Walters Camp Road, 3 Slashes Road & Painted Gorge Road Maintenance; County of Imperial Project No. 6982MAINT

ADDENDUM NO. 1

October 18, 2022

FEDERAL AND STATE REQUIRED CONTRACTOR'S EMPLOYEE NOTICES AND POSTERS

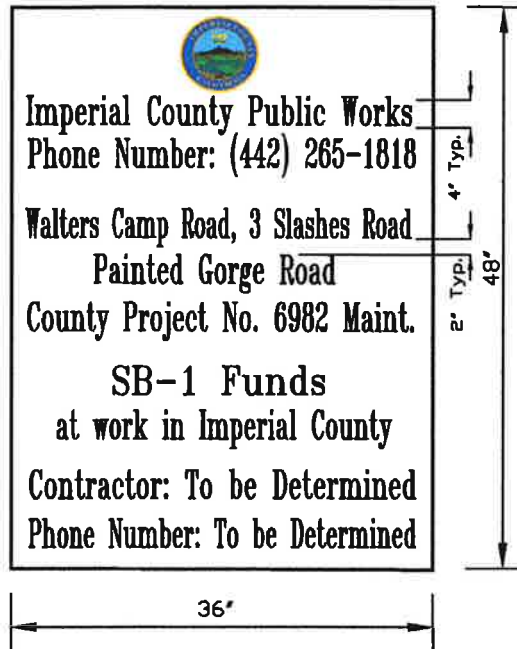
3. Question: “Section 12-3.11C(3) mentions that the contractor is to provide and place two Project ID signs. Since there are three locations of maintenance, will three signs be required instead of two?”

Response: Provide and place two Project Identification Signs and Contractor’s Employee notice Signs on each location per **attached detail**. Full compensation for furnishing, installing, and maintaining Construction Area Signs, including all temporary signs and object markers required for the direction of traffic through or within the project limits, Imperial County project identification signs, and project funding signs, shall be considered as included in the contract lump sum price paid for the various items of work and no additional compensation shall be allowed therefor.

NOTE: THE CONTRACTOR SHALL INSTALL TWO (2) SEPARATE CONTRACTOR IDENTITY AND CONTRACTOR'S EMPLOYEE NOTICE SIGNS OR USE ONE SET OF SIGN POSTS AND MOUNT THE CONTRACTOR IDENTITY AND THE CONTRACTOR'S EMPLOYEE NOTICES ON OPPOSITE SIDES OF THE SIGN POST. THE CONTRACTOR IDENTITY SIGN MUST FACE THE PUBLIC AT THE LOCATION DESIGNATED BY THE AWARDED AGENCY. IF TWO (2) SEPARATE SIGNS ARE INSTALLED, PLACE THOSE SIGNS IN CLOSE PROXIMITY.
